From: "Timothy Walters" <timothy.r.walters@state.or.us>
To: "Timothy Walters" <timothy.r.walters@state.or.us>, "Vaughn Collins" <vcollins@nhcweb.com>
Cc: "bsdd.bos@gmail.com" <bsdd.bos@gmail.com>, "Michael Gray" <michael.e.gray@state.or.us>, "Nehalemmarine@gmail.com" <Nehalemmarine@gmail.com>, "SteveDenney" <sdenney@tnc.org>, "Stuart Love" <stuart.l.love@state.or.us>, "LEO KUNTZ" <tidegates@yahoo.com>
Date: 07/30/2014 01:49 PM
Subject: RE: Notes from 7/18 Passage meeting

From: "Timothy Walters" <timothy.r.walters@state.or.us>
To: "bsdd.bos@gmail.com" <bsdd.bos@gmail.com>, "Michael Gray" <michael.e.gray@state.or.us>, "Nehalemmarine@gmail.com" <Nehalemmarine@gmail.com>, "SteveDenney" <sdenney@tnc.org>, "Stuart Love" <stuart.l.love@state.or.us>, "LEO KUNTZ" <tidegates@yahoo.com>, "P. E. CFM Vaughn Collins" <vcollins@nhc-sea.com>
Date: 07/23/2014 04:37 PM
Subject: Notes from 7/18 Passage meeting

DRAFT C3R/Winter Lake Velocity Duration and Gate Open Time

Figure 1: Maximum and Minimum Observed Daily Water Level – Coquille River @ BSDD Outlet

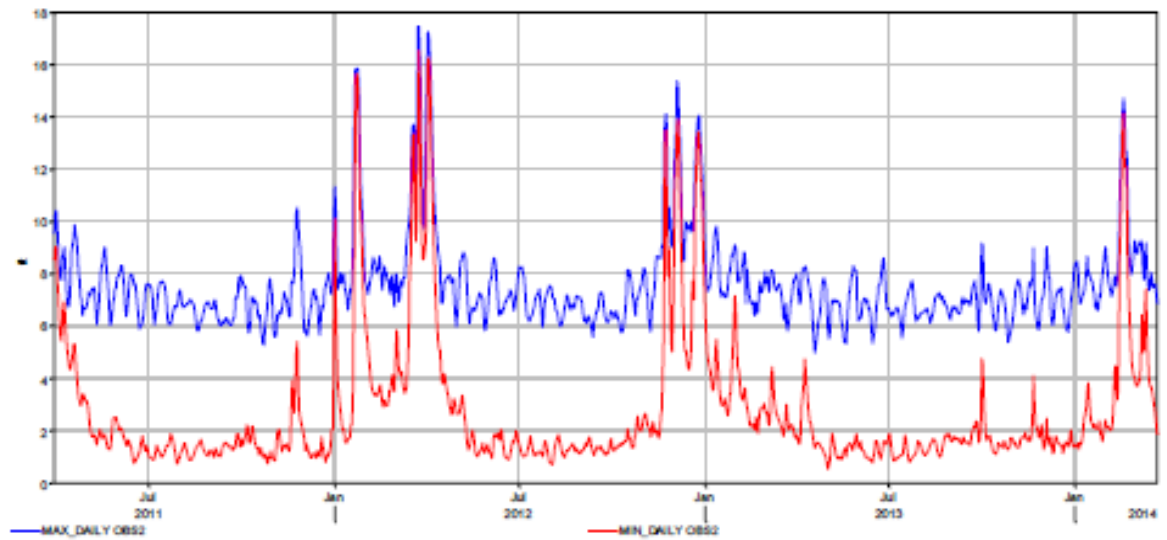
The maximum and minimum daily stage were extracted and are shown in Figure 1. The minimum daily

Figure 2

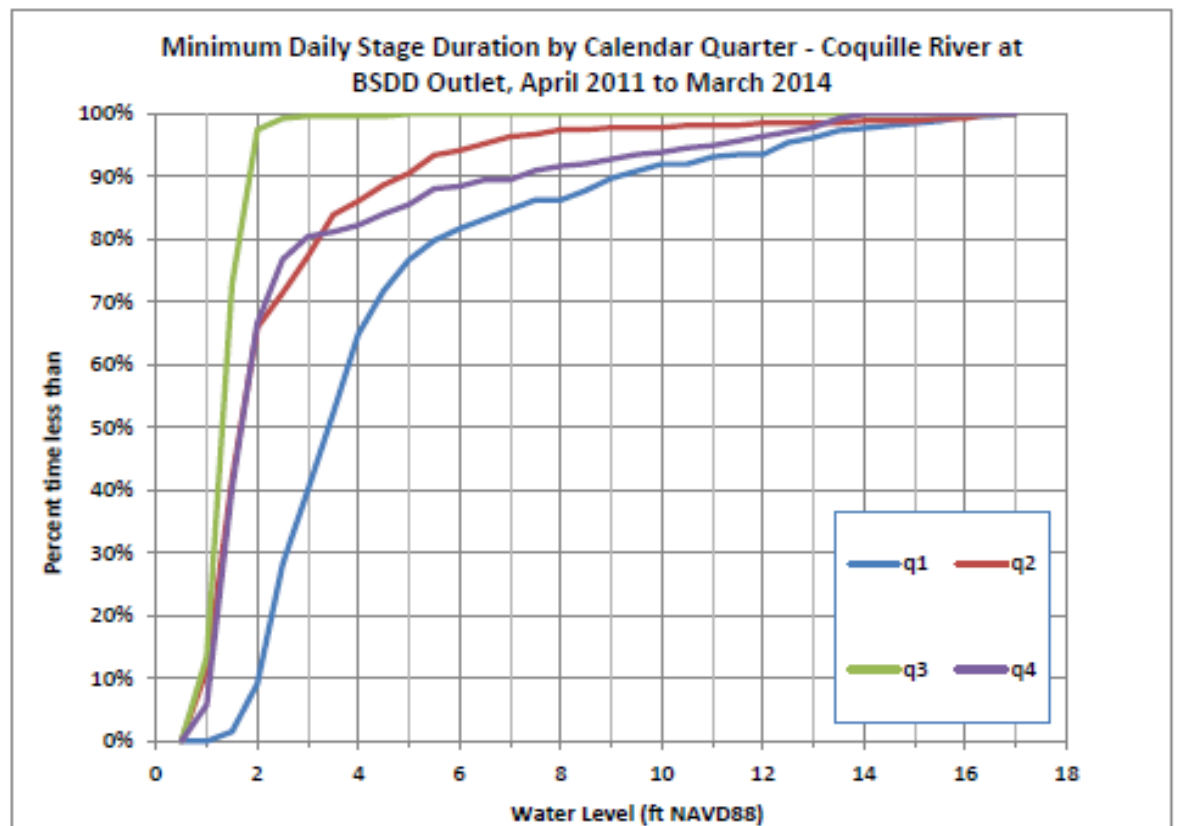
Based on the figures, it appears that the minimum stage would be less than the 5.5 set point 80%,94%, 100% and 88% of the time for the first through fourth quarters for the period of record examined.

Unless I misunderstand the information, this would mean that the gates would be open 80%,94%, 100% and 88% of the time during minimum stage, but not open during intermediate stages or high stage. As such, the percentage of time the gates would be open would be approximately $\frac{1}{4}$ to $\frac{1}{2}$ of the percentages listed.

Please correct me if needed.

stage data was then grouped by calendar quarter in order to allow evaluation during different periods of fish use. The resultant duration of minimum stage exceeded by quarter is shown in Figure 2.

When the minimum daily stage is below the setpoint we can assume that the gates will be operational and the previously supplied gate open duration figures are applicable. When the minimum daily stage is above setpoint elevations a conservative assumption is that the gates are not open. In fact there will be times when the gates do open on the receding limb of a high water event - this analysis method cannot capture that. In addition, when water levels exceed around 14 feet there is exchange with the river over the Beaver Slough banks. (The data indicates that some overtopping occurs at around 12 feet, but significant volumes do not occur until 14 feet).

For example, if we look at Figure 2 and assume 5.5 feet as a setpoint elevation, the gates would be operational 80%, 94%, 100% and 88% of the time for the first through fourth quarters for the period of record examined. The previous winter low flow analysis velocity duration curves indicated the Unit 2 gate would be open around 65% of the time at a 5.5 foot setpoint. Accounting for higher flows, the Unit 2 gates would be open 80% of this, or 49% of the time from Jan-Mar. Again, there would be times when water levels exceed 5.5 feet that the gates would be open or levee overtopping occurring, bumping back up the percentages to some degree. Spring and Fall have less high flow gate restrictions, and the summer quarter has none.

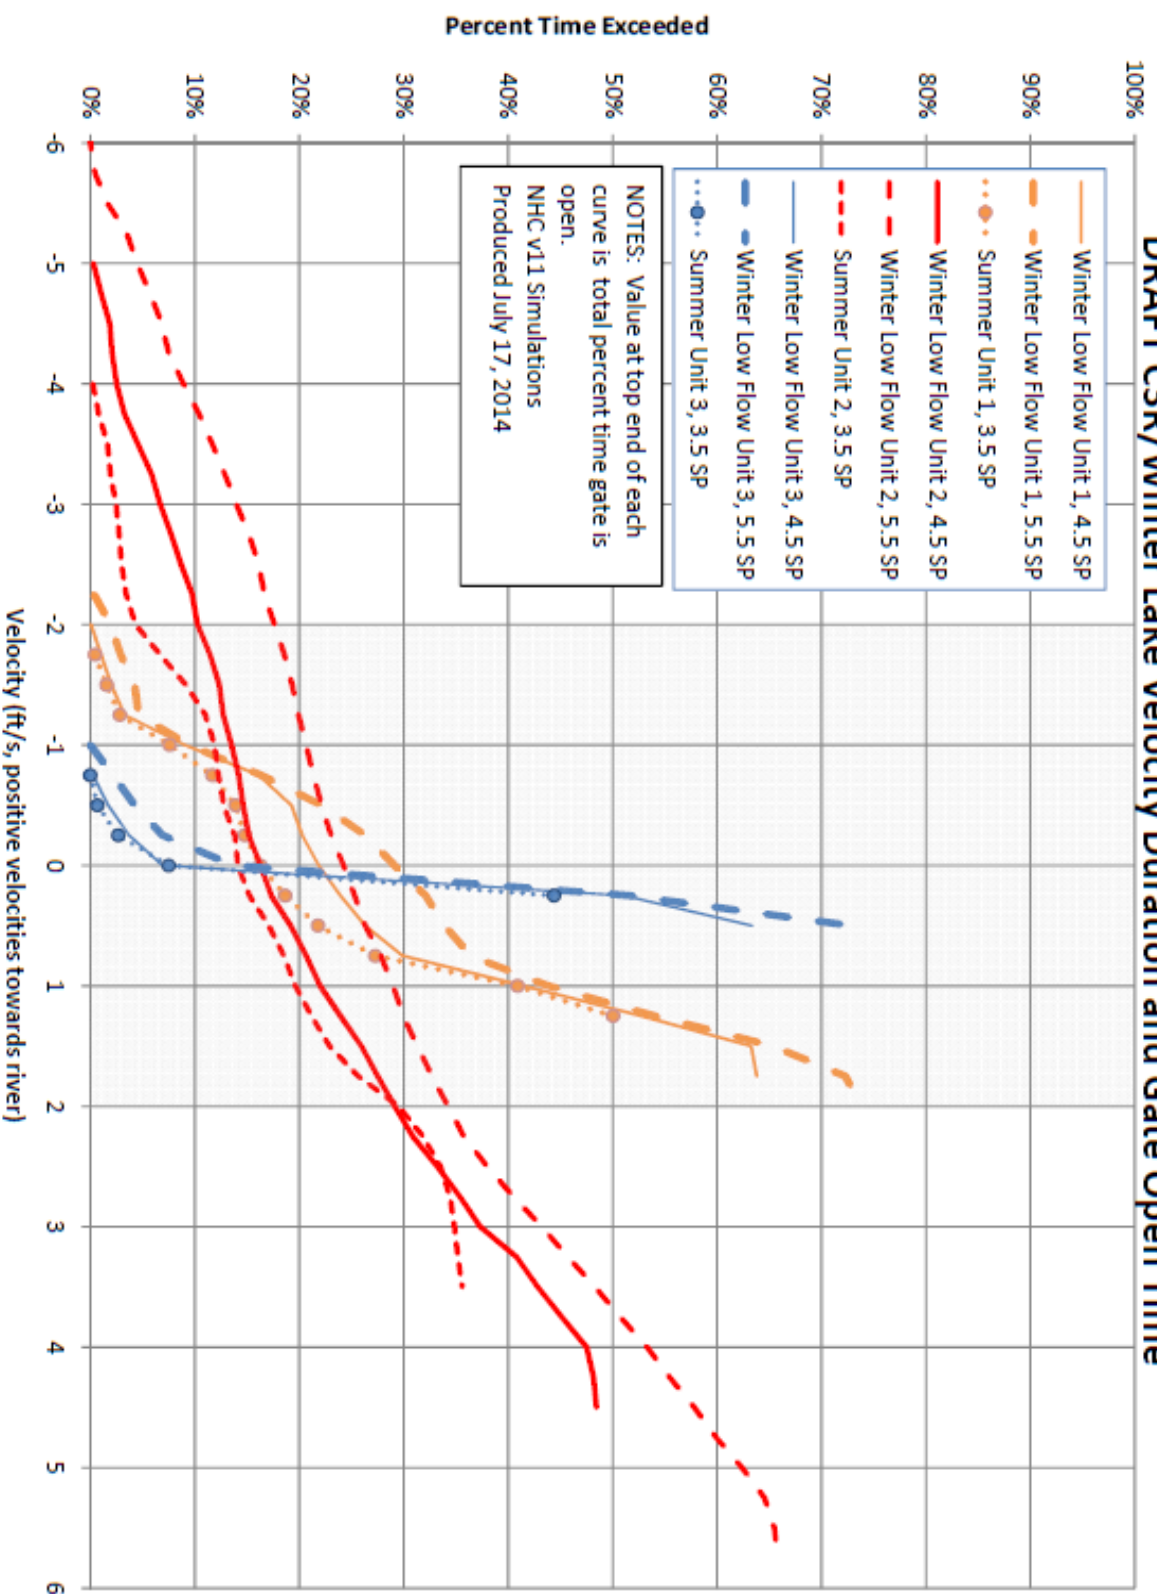
Leo Kuntz noted that high velocities (above 4 fps) are very problematic. Challenging to ensure structure is not damaged.

Leo noted that we would be better off setting a maximum water velocity of 4 fps. Based on the model, a set point for the muted tidal regulators at 4.5 feet would be best. Set point of 5.5 feet results in the highest water velocities.

Leo noted that during low flow periods, such as summer, gates would be open more if Unit 2 was operated at 5.5-6 ft. However, this would yield higher velocities.
